ADMINISTRATIVE APPROVALS

July 18th, 2018

1. 46 Maplewood Ave. (building height) - TBD
2. 299 Vaughan Street (misc. changes) - Recommend Approval
3. 10 Commercial Alley (HVAC vents) - Recommend Approval
4. 180 Gates Street (siding) - Recommend Approval

Application for Approval - Administrative Historic District Commission

Previously Approved Maplewood Avenue Elevation
SCALE: N.T.S.

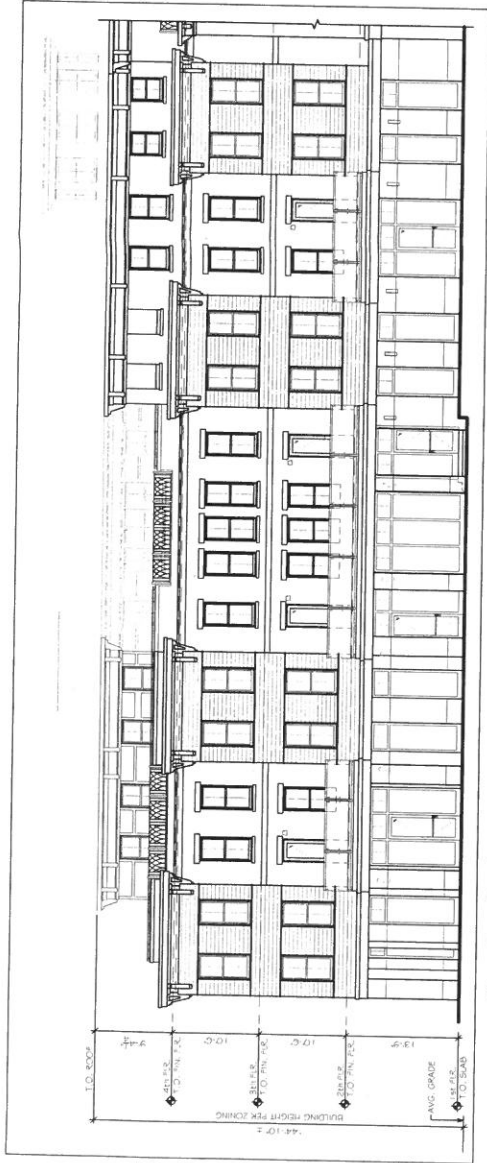
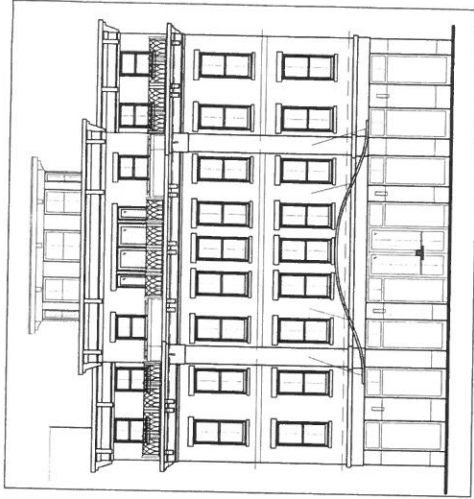
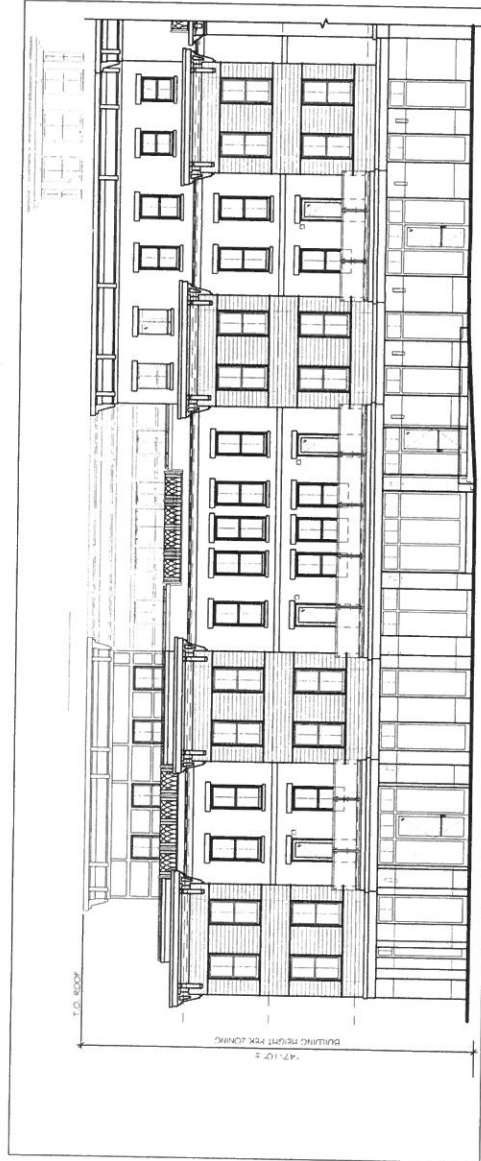
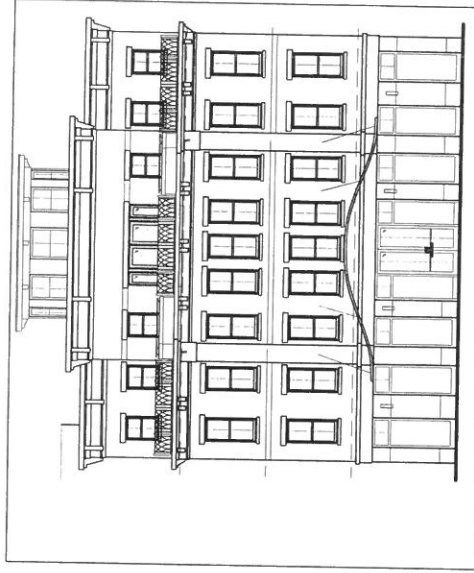
To permit the following: AMENDMENT TO PREVIOUSLY APPROVED APPLICATION TO ALLOW A BUILDING HEIGHT OF 47'-10 WHERE 44'-10 WAS APPROVED.

Action Taken by H.D.C. at Public Meeting	
Date of Approval:	<u>7.11.18</u>
Recommendation:	<u>GRANTED CONT.</u>
Stipulations:	<u>1. THE H.D.C. SUPPORTS AN AMENDMENT TO THE CUP.</u>
Signature of Principal Planner:

4.2a

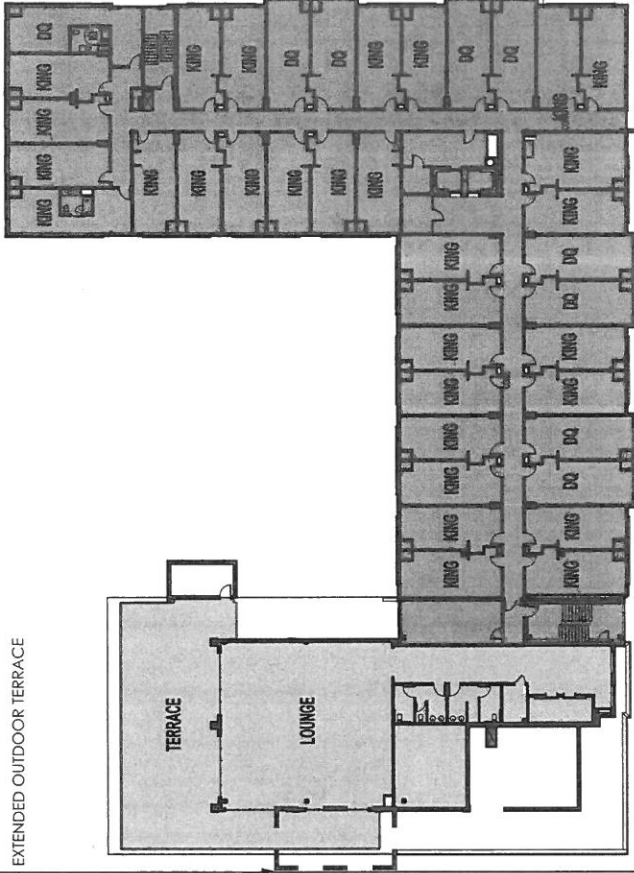
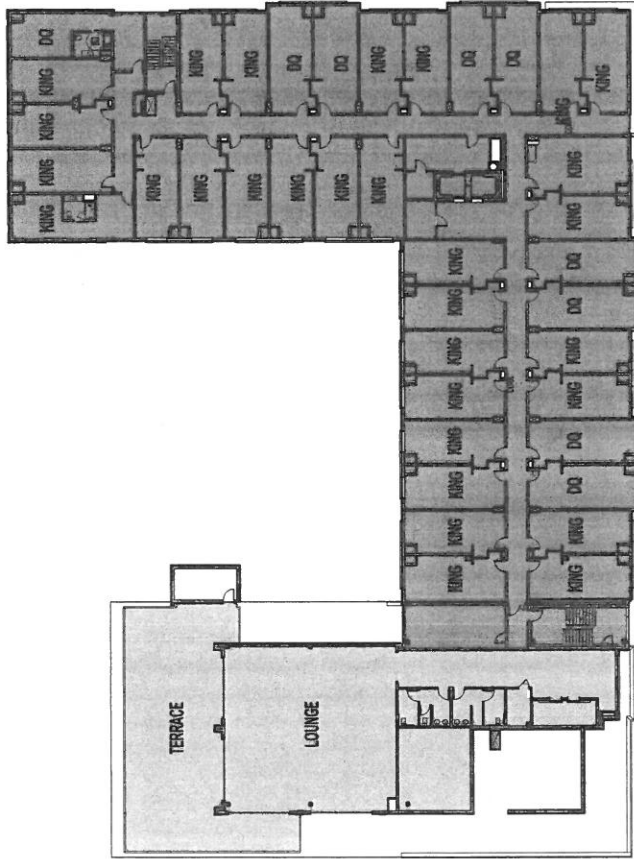
- 1) Add "Night Rendering", sheet 2.0a, to represent the buildings exterior lighting.
- 2) Revised "Pocket Park Perspective" rendering view. See sheet 2.3.
- 3) Extended 4th floor Bar Terrace. See sheet 4.2a.
- 4) Change aluminum composite lintel trim from "FAUX ZINC CHARCOAL" to "BLACK" See sheet 8.2.
- 5) Exterior Lighting Fixtures. Sheets 8.4 and 8.5.

SOUTH ELEVATION

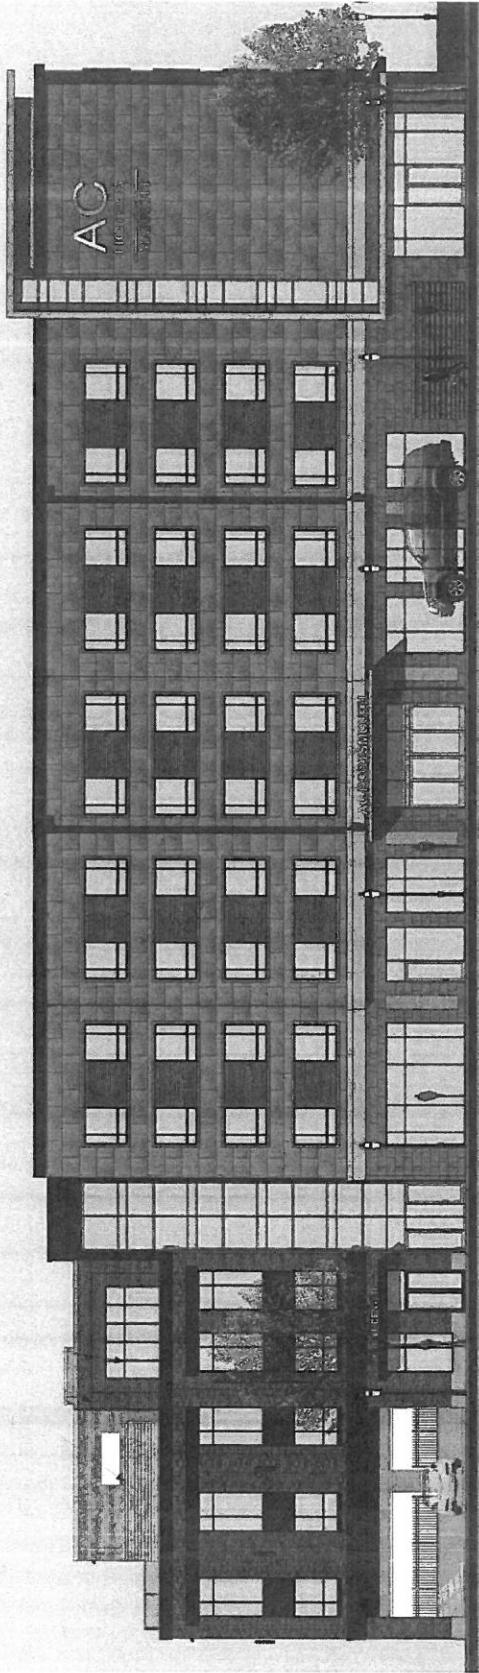
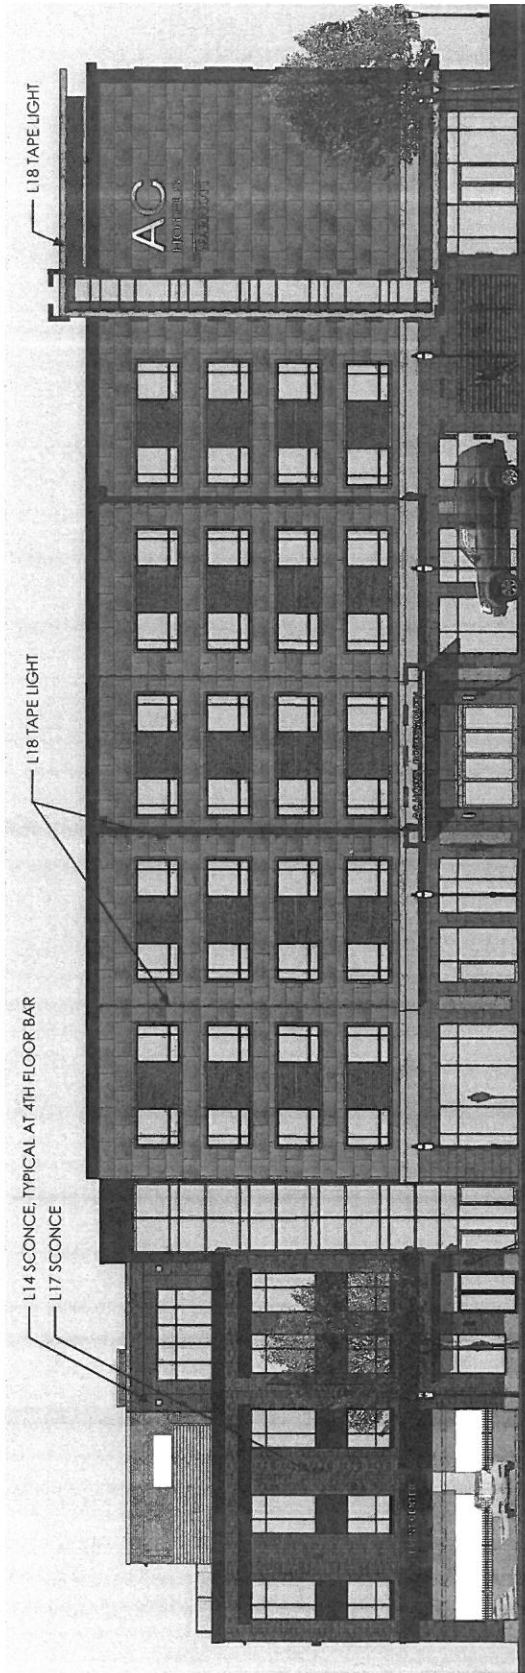
- 6) Change primary hotel entrance door to automatic bi-parting glass entrance doors.
- 7) Adjusted length and height of horizontal wood slats.
- 8) Horizontal curtainwall muntins adjusted.
- 9) Add exterior lighting to building.
- 10) Relocated "Event Center" signage.

EAST ELEVATION

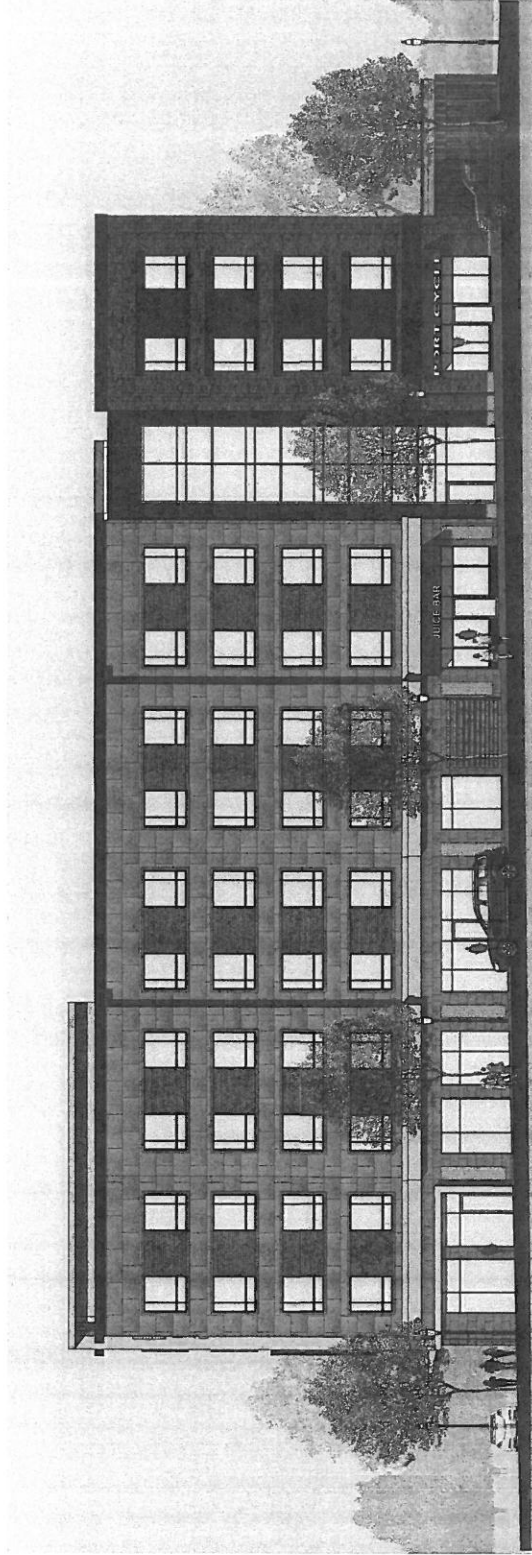
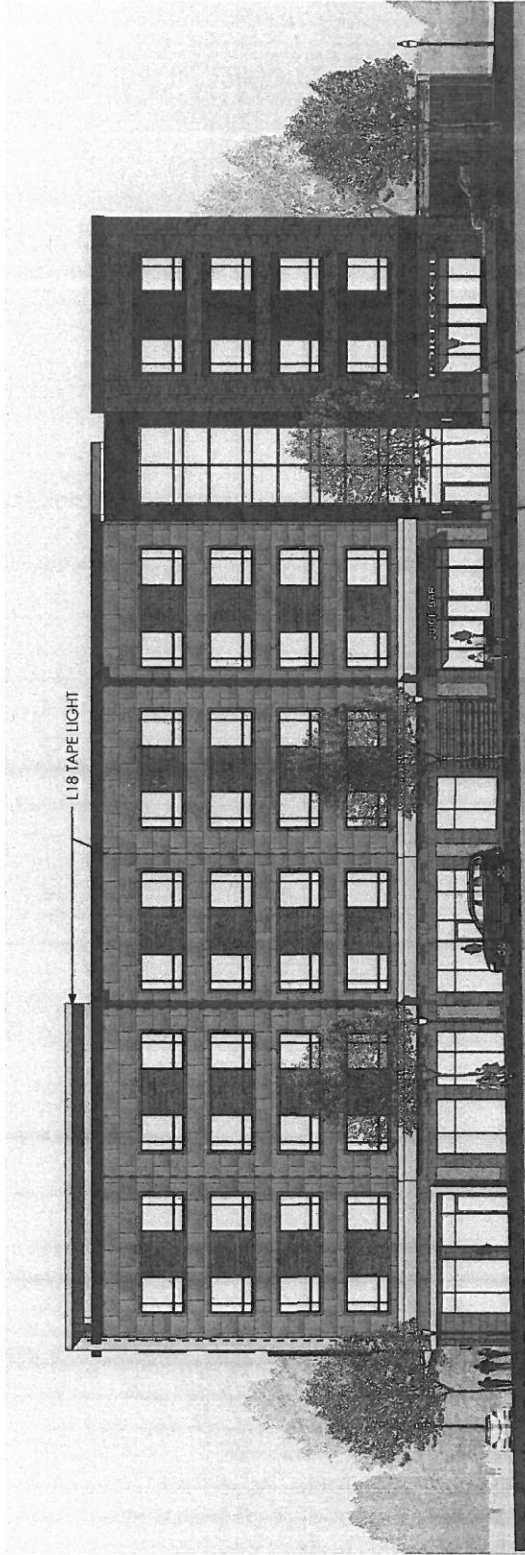
1. LED accent lights added to structure. **Please note:** accent lighting is treated as signage and will require a sign permit in addition to HDC approval.

- 11) Exterior door height increased to 8 feet. Adjusted horizontal muntin at storefronts to align.
- 12) Adjusted length and height of horizontal wood slats.
- 13) Add exterior lighting to building.

(Response) See attached revised exterior elevations for exterior lighting locations. HDC application for administrative approval will be submitted along with colored elevations, night rendering and other required documentation.

NORTH ELEVATION

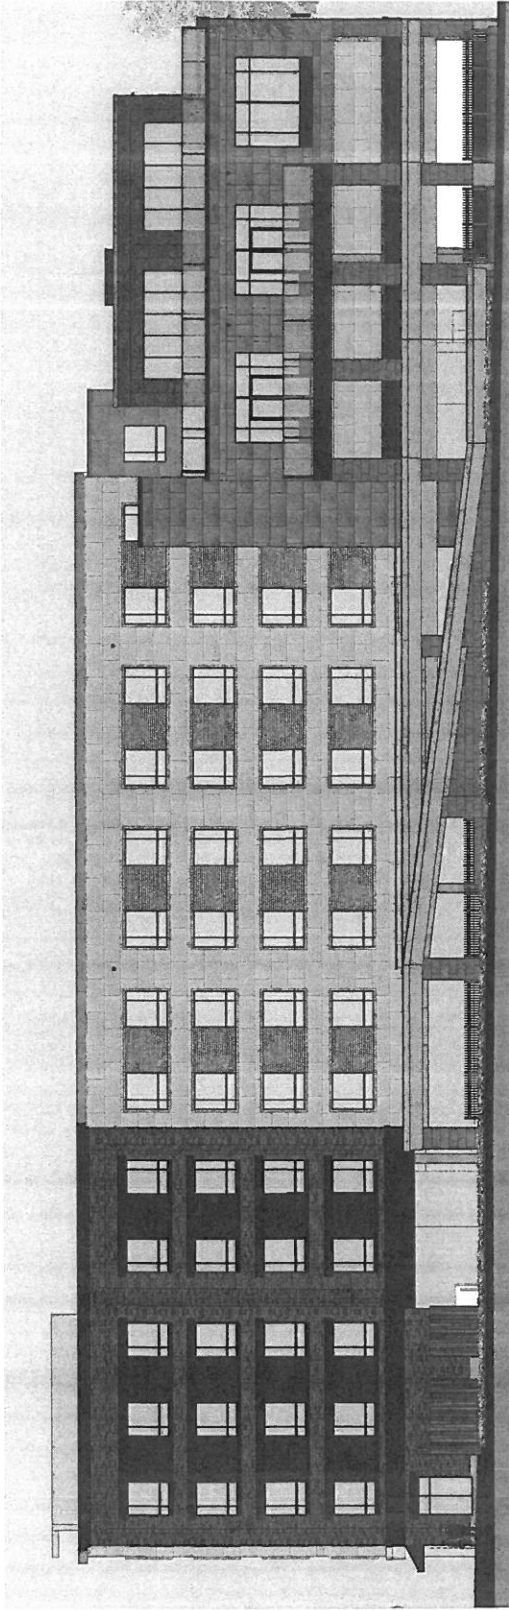
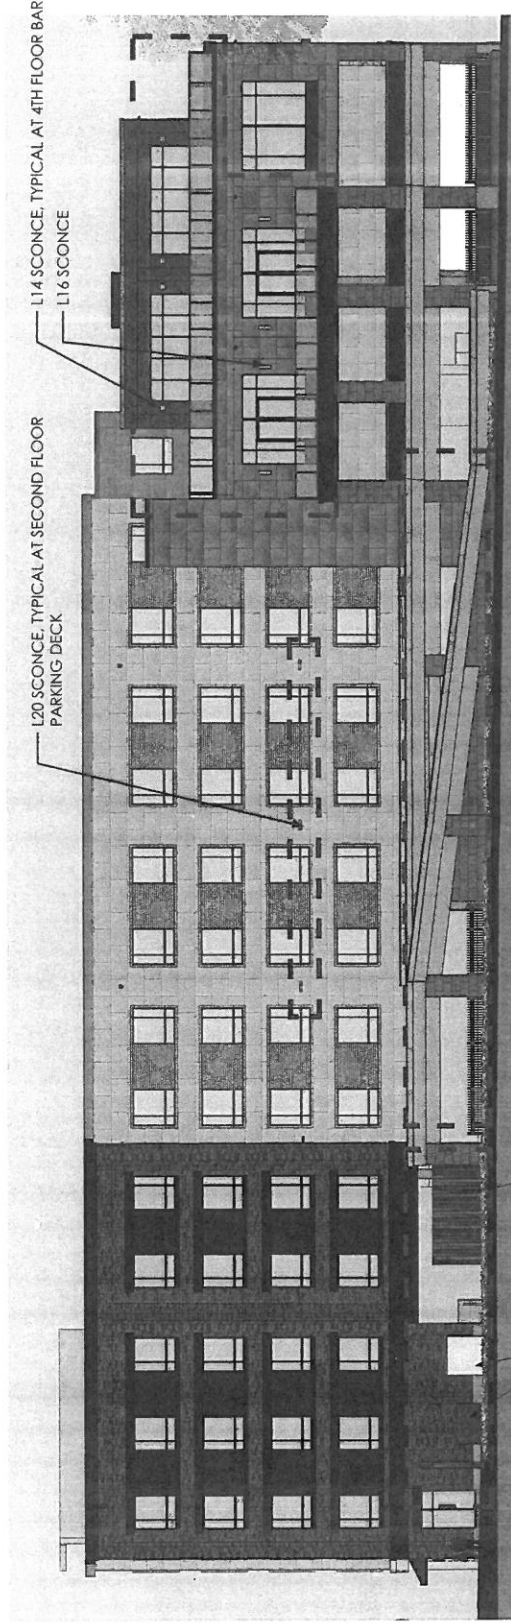
1. 2nd floor window rounded.

2. Retaining wall lowered.

- 14) Relocate trash enclosure, transformer and generator.
- 15) Adjust metal band at vehicle ramp.
- 16) Adjust glass railings.
- 17) Relocated 5th floor guest room window.
- 18) Add exterior lighting at parking deck, meeting room and bar terrace.
- 19) Add horizontal muntin at window systems.

(Response) The windows have not been rounded. This is a detail reference bubble around the window within the permit drawings.

(Response) The retaining wall was lowered and approved by HDC on 3/7/18.

WEST ELEVATION

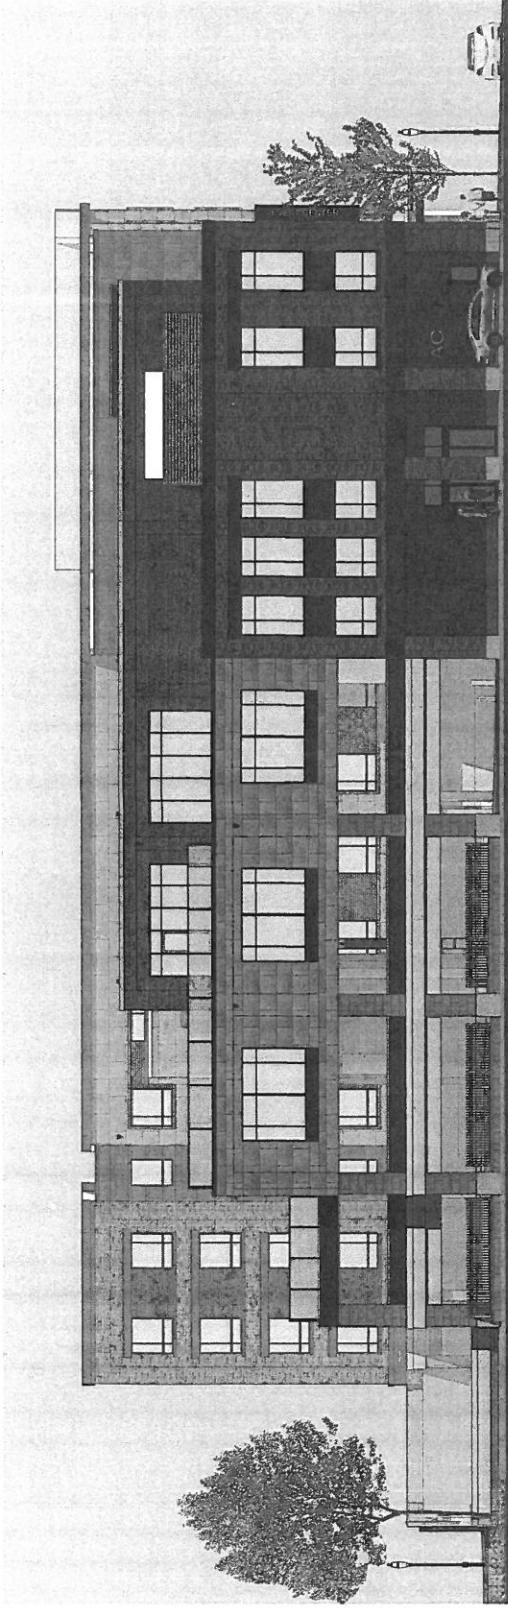
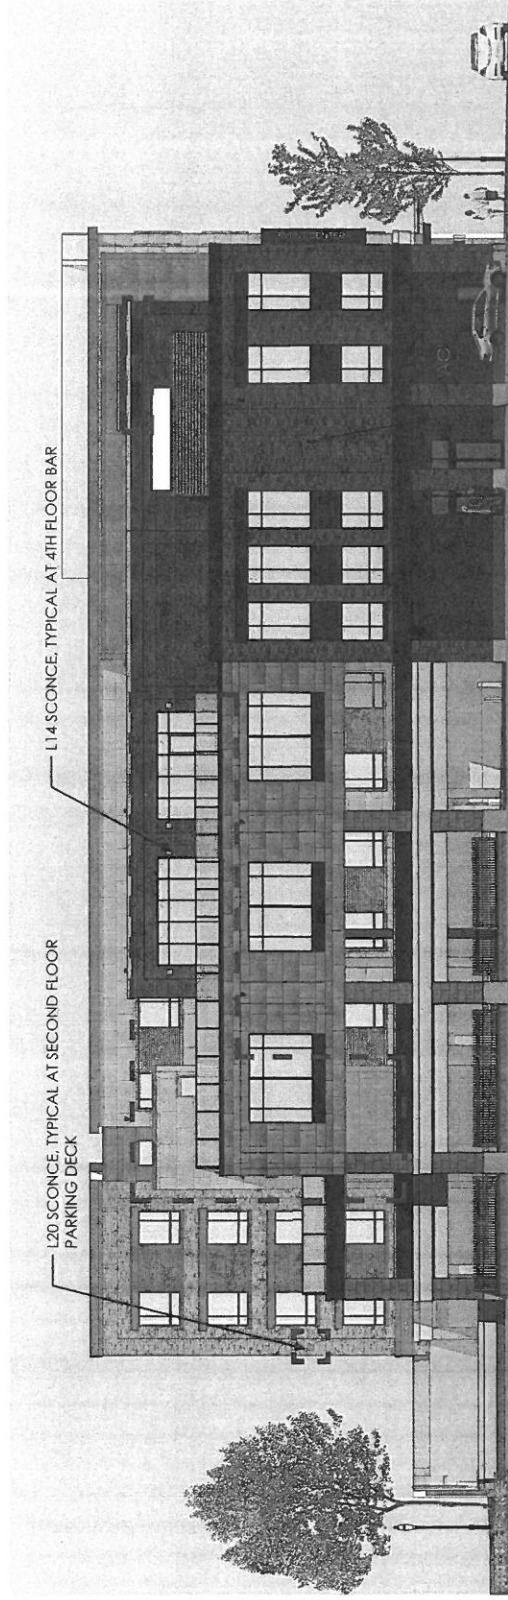
1. Stairwell may have changed location (former location also shown).

2. 2x louvers added.

- 20) Shift stair tower to align with plan view.
- 21) Add elevator vent louvers.
- 22) Adjust glass railings.
- 23) Adjusted storefront and door location.
- 24) Add exterior lighting at parking deck and bar terrace.

(Response) The HDC approved the revised location in plan view on 3/7/18. See attached updated West Elevation, sheet 2.1, along with an HDC application for administrative approval to show the correct location in elevation.

(Response) See attached updated West Elevation, sheet 2.1, along with an HDC application for administrative approval to show added required elevator venting louvers.

PROPOSED MATERIALS

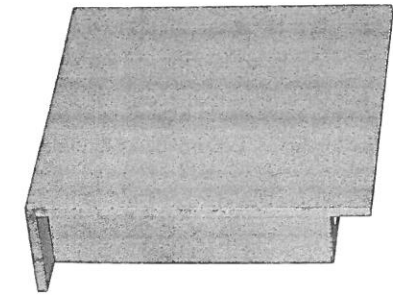
(Response) Yes, all the materials and colors shall be as represented on the “Proposed Materials” sheets 8.0, 8.1 and 8.2 of the June 7, 2017 submission, except for the Aluminum Composite Lintel Trim indicated on sheet 8.2. The Aluminum Composite Lintel Trim will be modified from “Faux Zinc Charcoal” to “Black”. An application for administrative approval to the HDC will be submitted.
